Dansk Data Elektronik A/S

**Technical
Field Change Notes**

Updated 1st November 1996

CPU 4501, ISS 1. Solder side.

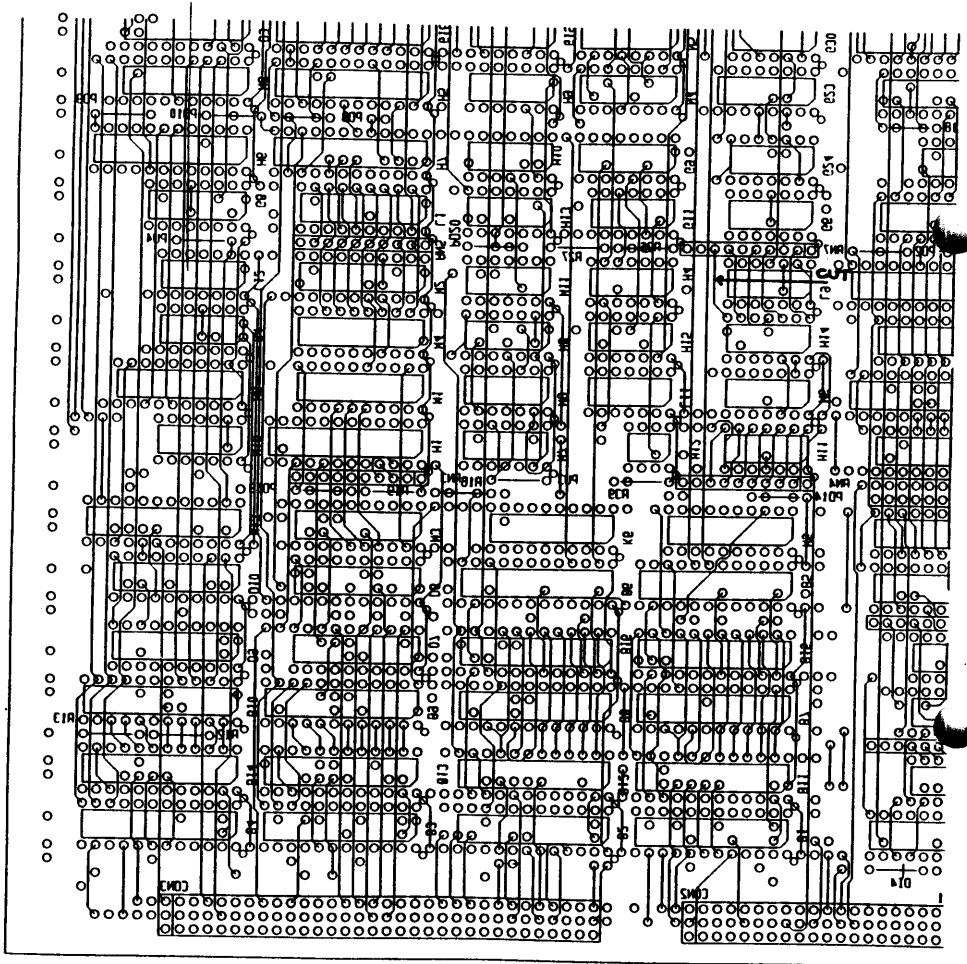
Circuits involved:

Name	Type	Position
RN7	SIL	H6
H14	SWITCH	H5

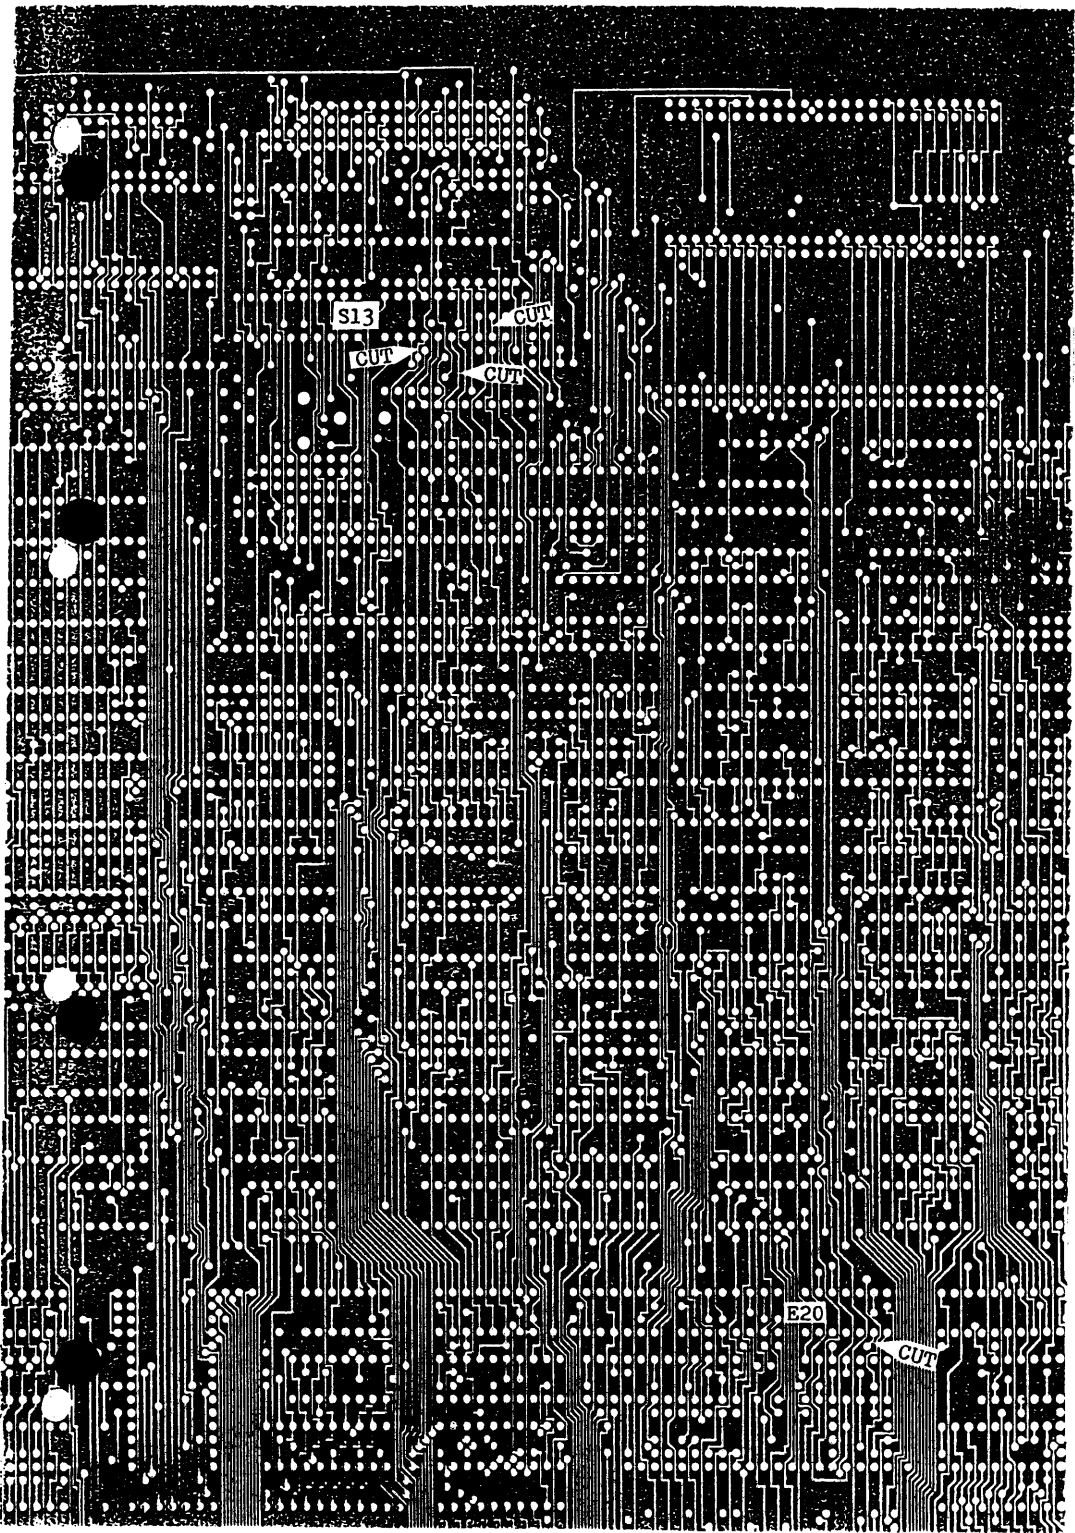
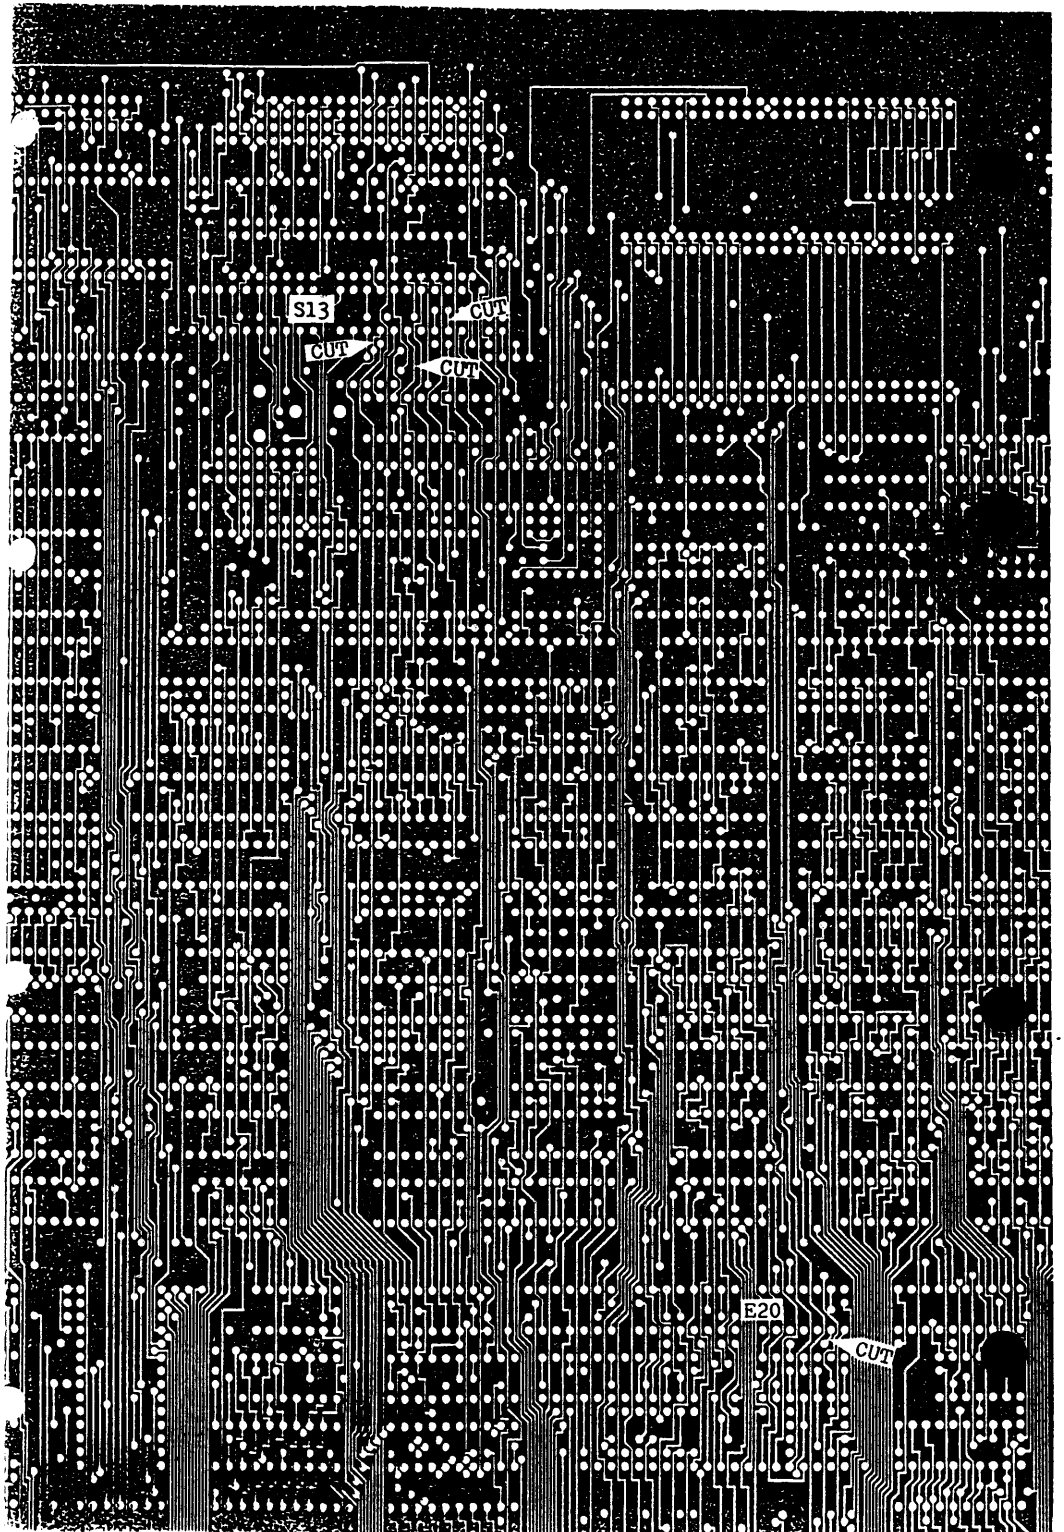
CIRCUITS INVOLVED:

Name	Type	Position
S13	PAL D2P60	B 13,5.
D2	2681	B 13,2.
S3	74LS273	B 11,7.
S10	74S74	B 11,5.
S18	74S74	B 12,7.
E20	74S00	A 11,8.
G6	74S04	B 1,3.

CUT

CUT

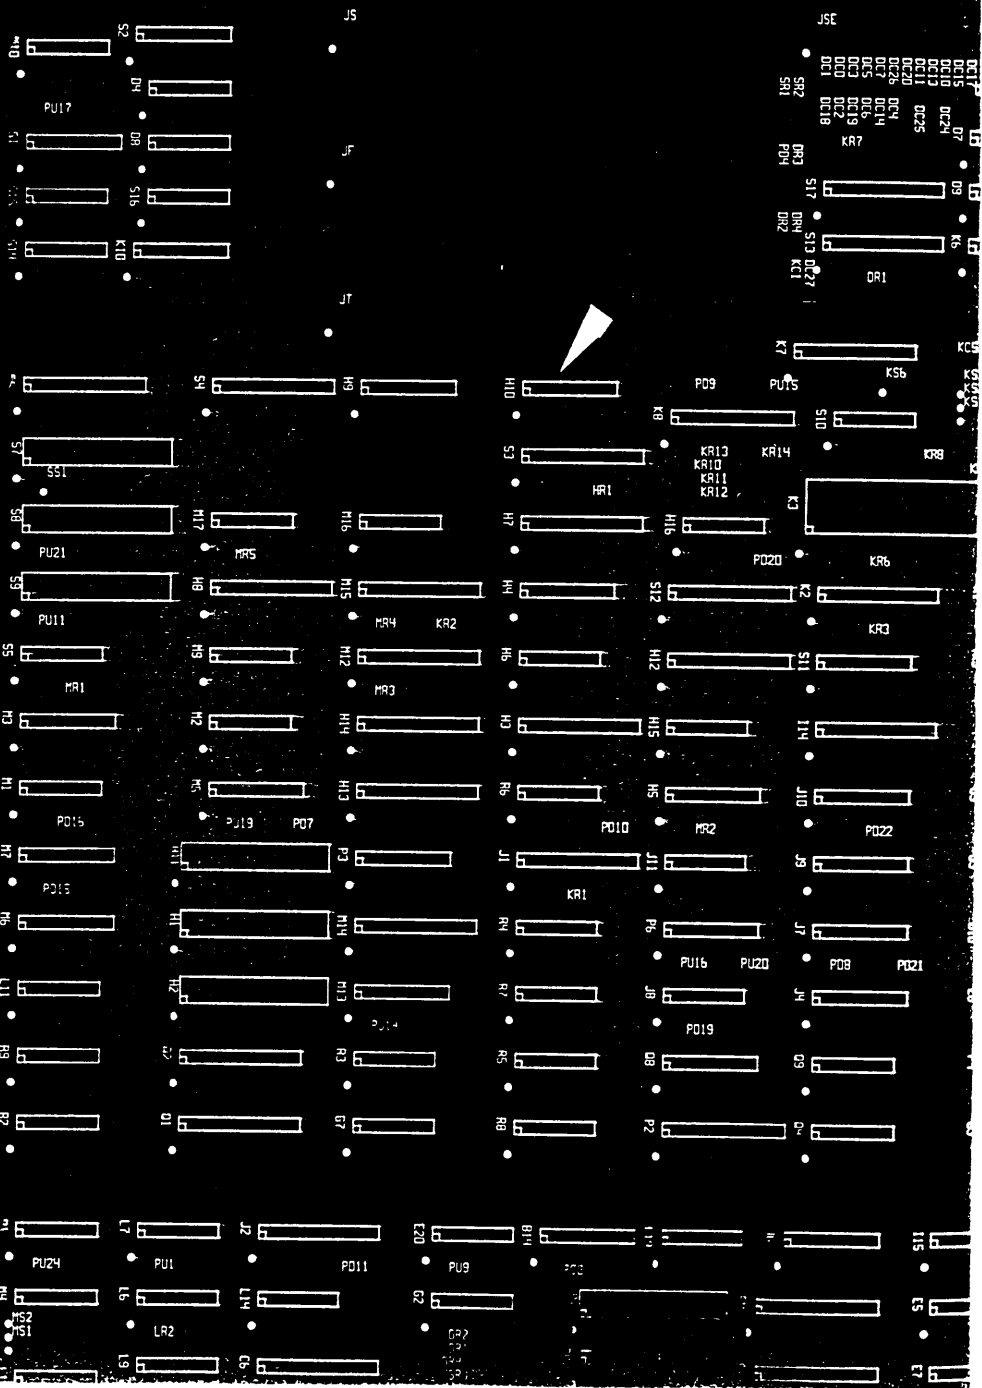
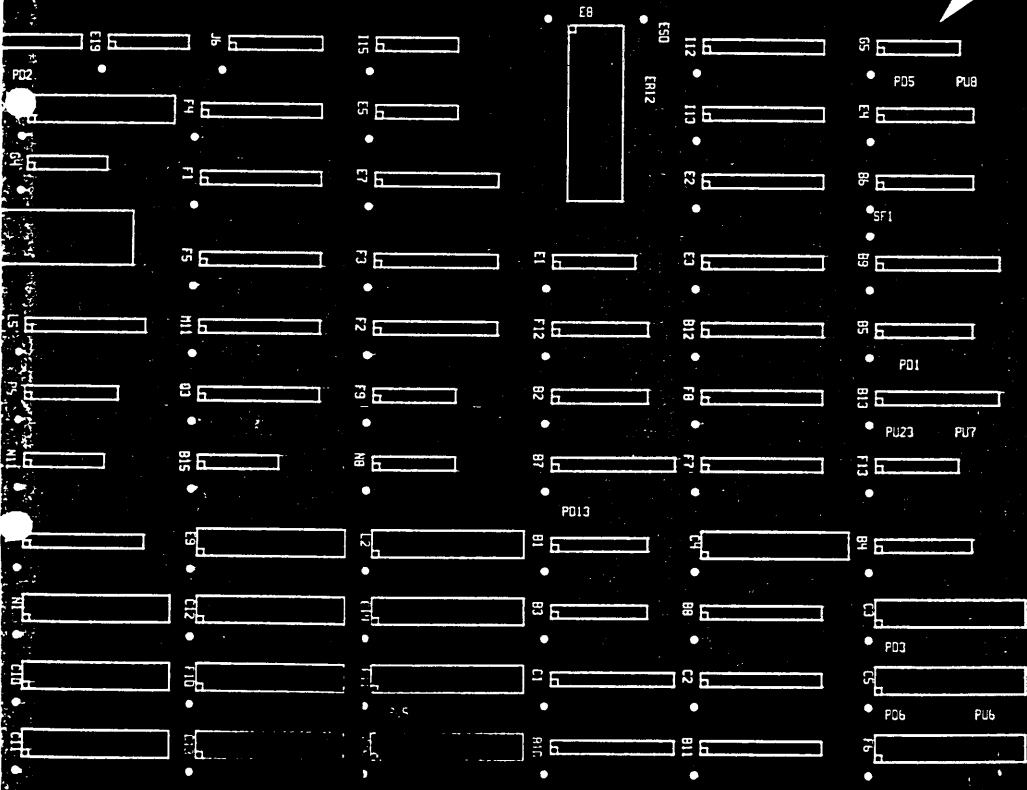
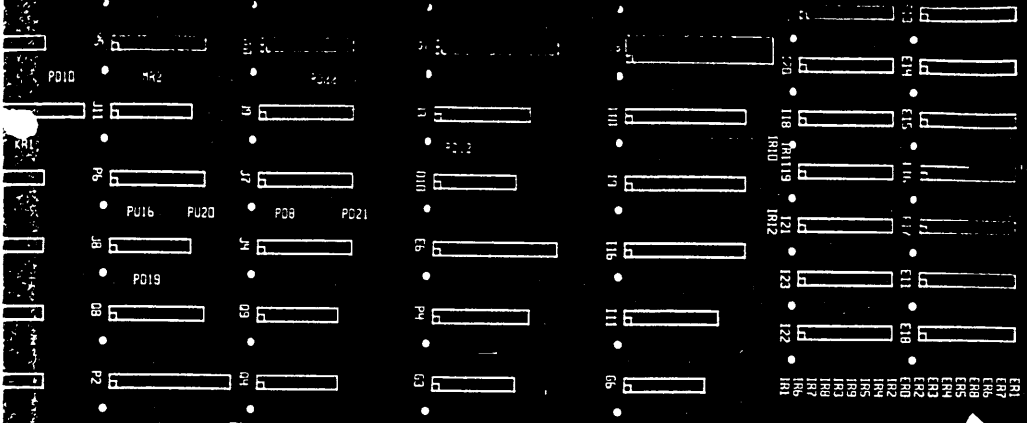
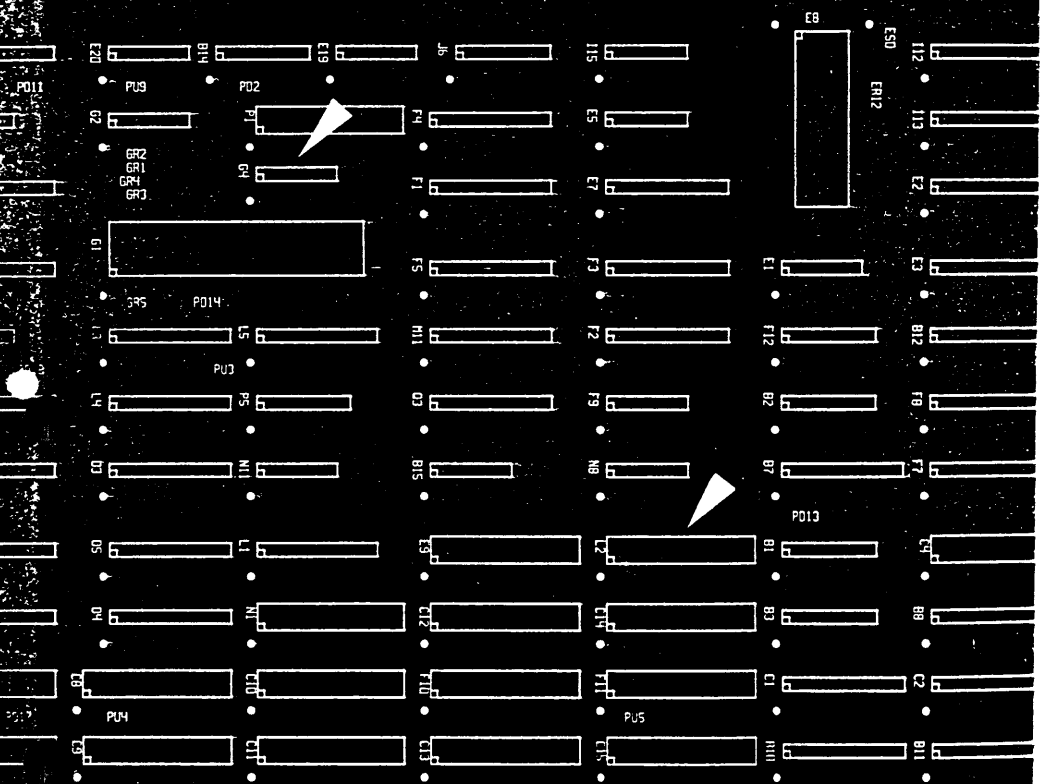
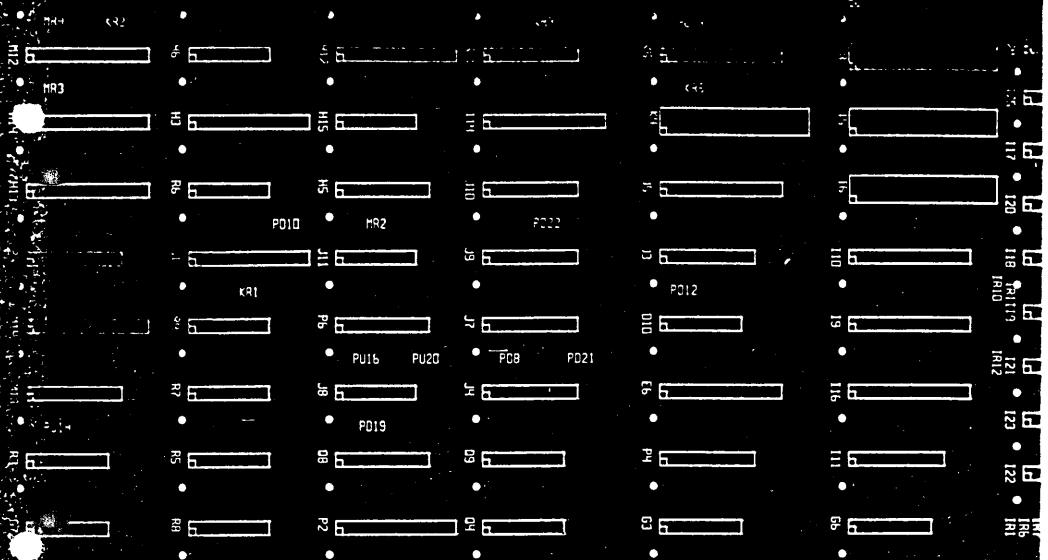
Package H10 is 74S74, position B 12,7.

Connect 1k ohm resistor between H10 pin 14 and H10 pin 10 on solder side of the board.

Package G5 is 74S00, position A 11,1.

Board layout details DIOC4000.

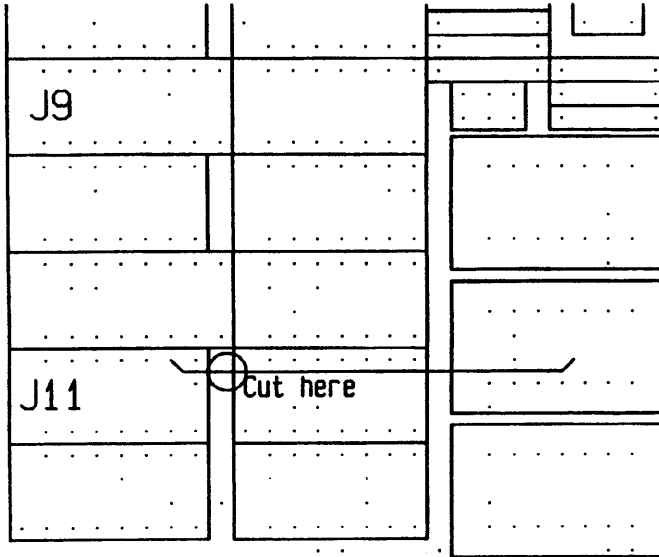
1. Cut the connection between J8 pin 5 and J11 pin 9 on the component side of the PCB. (See the drawing on page 2, regarding the location of that connection.)
2. Connect J9 pin 6 and J11 pin 9 using insulated wire on the component side of the PCB.
3. Update the PCB revision field:
 - DIOC4000 ISS 1: Update to revision K by removing the letter J in the PCB revision field label.
 - DIOC4000 ISS 2: Update to revision G by removing the letter F in the PCB revision field.

Name	Type	Position
J9	74LS390	L15
J11	74AS1004	L13

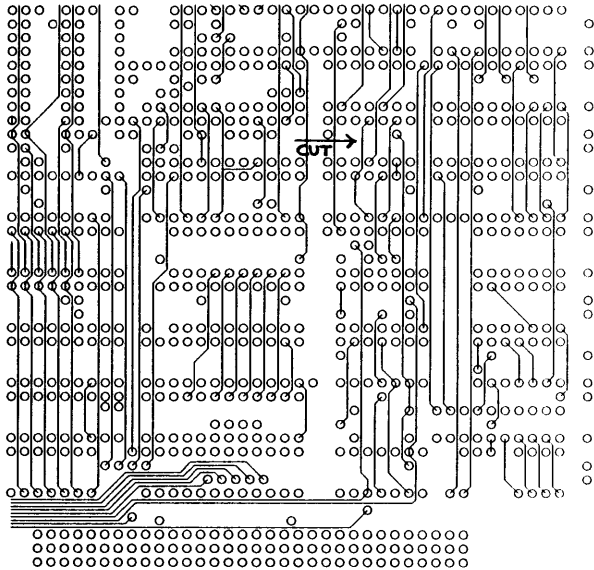
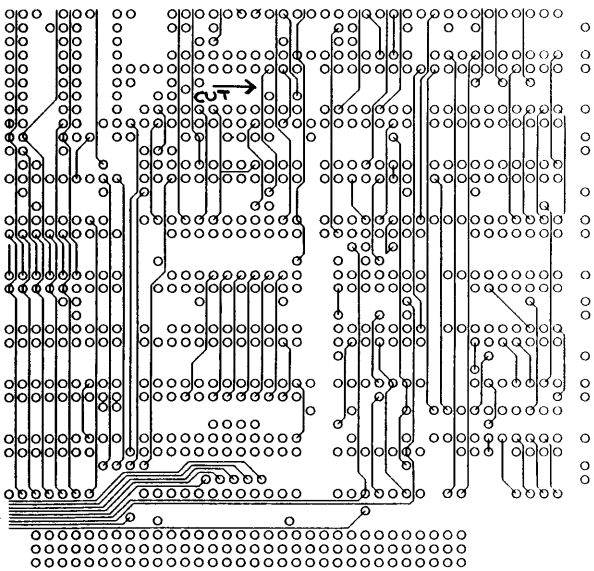
1. Cut the PCB wire on the solder side of the PCB. See the attached page.
2. Connect P5 pin 11 to O6 pin 10 with insulated wire on the component side of the PCB.
3. Change PAL L1 to D3162.
4. Update PCB revision field:
 - 4000 ISS 1: Update to revision H by removing the letter G in the PCB identification field.
 - 4000 ISS 2: Update to revision E by removing the letter D in the PCB identification field.

Name	Type	Position
P5	74F74	B4
O6	74F74	B3
L1	D3161	A4

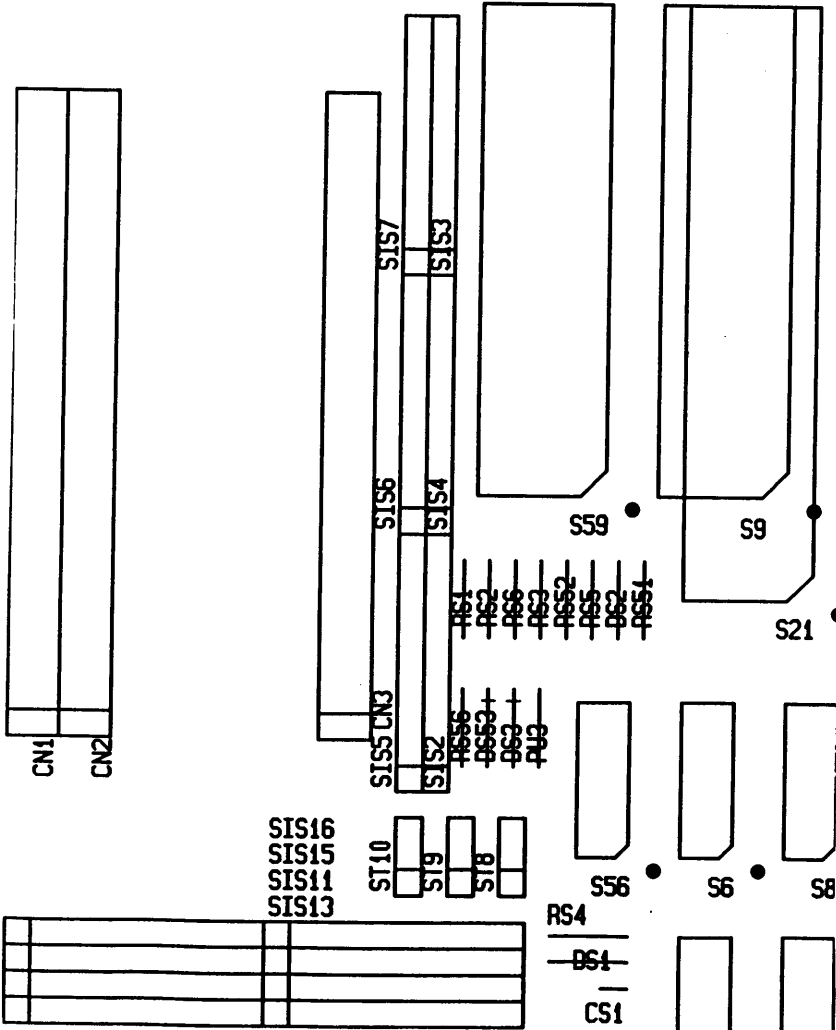
1. Replace diode DS3 and DS53 with 1N5818 types.
2. Connect strap ST10 pin 2 to connector CN3 pin 26 with insulated wire on the solder side of the PCB.
3. Strap ST8 provides termination power to SCSI interface 0. Set strap to short between pin 2 and 3.
4. Strap ST10 provides termination power to SCSI interface 1. Set strap to short between pin 2 and 3.
5. Update PCB revision field:
 - 4000 ISS 1: Update to revision G by removing the letter F in the PCB identification field.
 - 4000 ISS 2: Update to revision D by removing the letter C in the PCB identification field.

Name	Type	Position
DS3	Diode	C14
DS53	Diode	C14
ST8	Strap	C14
ST10	Strap	C14
CN3	Connector	C14
